Access Compliance Report

Public Rights-of-Way

Intersection ID: 5566	Main Street: HANBERRY_BV	Cross Street: BACK_CREEK_CHURCH_RD	Location: S
ADA ID: 80A9B3009B6D	Ramp Type: PerpDiag	Initial Pass/Fail: Fail	Overall Compliance: No
Severity Score: 8.75			
Codes/Mitigation Info/Possible Solution		Field Measurements/Component Compliance

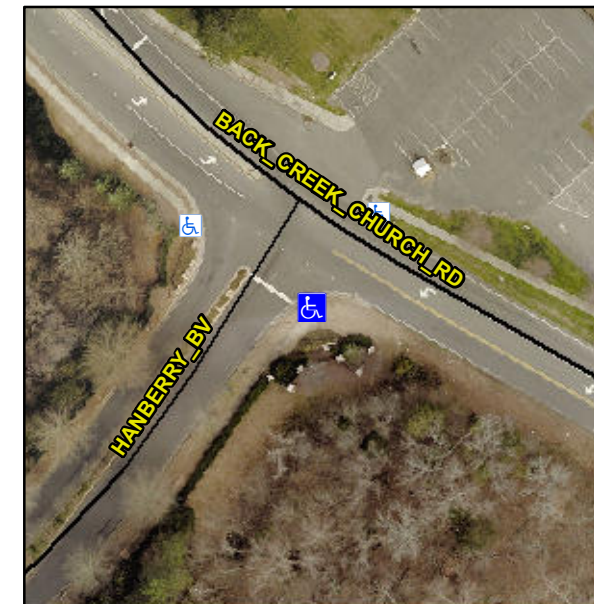
Not Found, R304.5.1

Compliance	Description	Data	Compliance	Description	Data
N/A	Ramp Length (in)	85.0	Yes	Ramp Slope (%)	7.2
No	Ramp Width (in)	47.0	Yes	Ramp XSlope (%)	1.4
N/A	Flare Type LT	N/A	N/A	Flare Type RT	N/A
N/A	Flare Slope LT (%)	N/A	N/A	Flare Slope RT (%)	N/A
N/A	Flare Traversable LT?	N/A	N/A	Flare Traversable RT?	N/A
N/A	Landing Length (in)	N/A	N/A	DWS Provided?	N/A
N/A	Landing Width (in)	N/A	N/A	DWS Contrast?	N/A
N/A	Landing Slope (%)	N/A	N/A	DWS Length (in)	N/A
N/A	Landing X Slope (%)	N/A	N/A	DWS Full Width?	N/A
N/A	Landing Curb? (Y/N)	N/A	N/A	DWS Offset (in)	N/A
N/A	Shared Landing?	N/A			
N/A	Gutter Ponding?	N/A	N/A	Gutter Slope (%)	N/A
N/A	Gutter Lip Ht (in)	N/A	N/A	Gutter X Slope (%)	N/A
N/A	Painted X Walk1?	No	N/A	Painted X Walk2?	No
	X Walk 1 Direction	To NE		X Walk 2 Direction	To NW
N/A	X Walk 1 Width (in)	N/A	N/A	X Walk 2 Width (in)	N/A
	X Walk 1 Slope (%)	6.1		X Walk 2 Slope (%)	5.5
	X Walk 1 X Slope (%)	2.4		X Walk 2 X Slope (%)	4.2

Remove & Replace Curb Ramp With Two New Directional Ramps or Equivalent.
